## CITY OF ALBUQUERQUE

Re: Drainage Ordinance (14-5-2-1) Violations for Erosion and Sediment Control

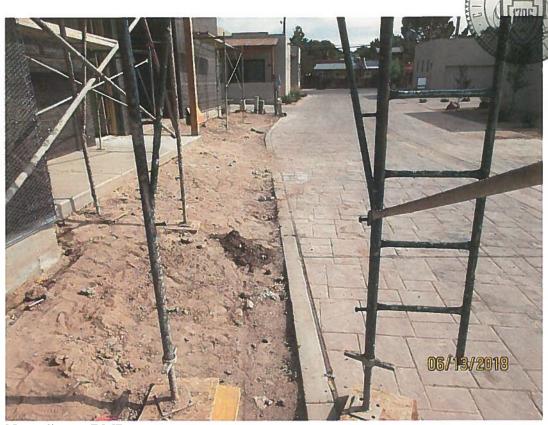
No sediment BMP and sediment in the street.

- 1. Install a sediment BMP (cutback/ mulch sock/wattle) on lots under construction.
- 2. Remove the wash-out from one of the lots and prevent this from occurring in the future.
- 3. Remove the sediment from Calle Obispo Lane.
